Response to the REA for the Amherst Island Windlectric Wind Energy Development

Shadow-Flicker

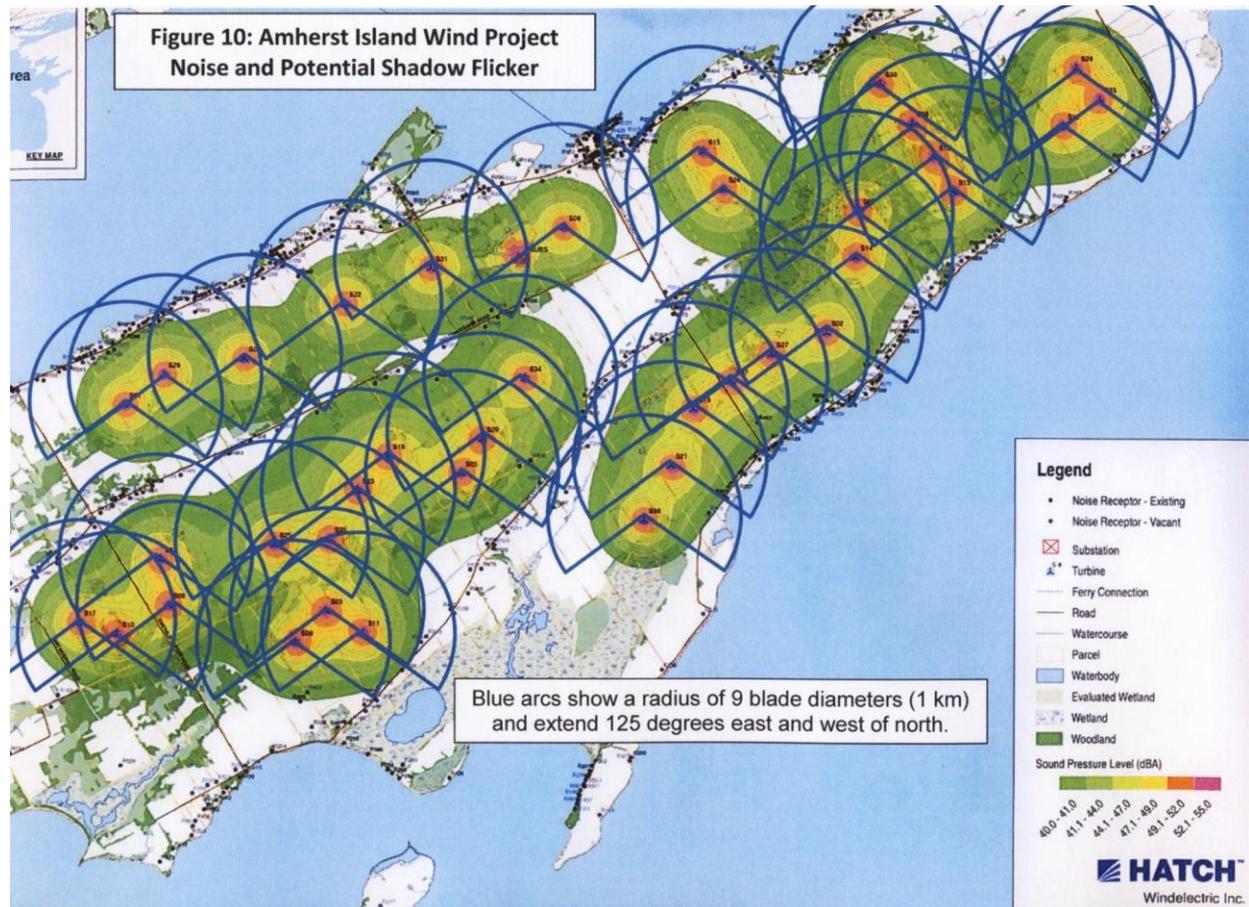
Amherst Island has lower latitude that most of Europe and so the 10 blade diameter arc has been reduced to 9 diameters. The resulting planning map for the island then looks as shown below. Almost every home within the study area lies within an arc. Clearly a full analysis was needed; as noted above Algonquin power did not have this done as part of the initial draft site planning document.
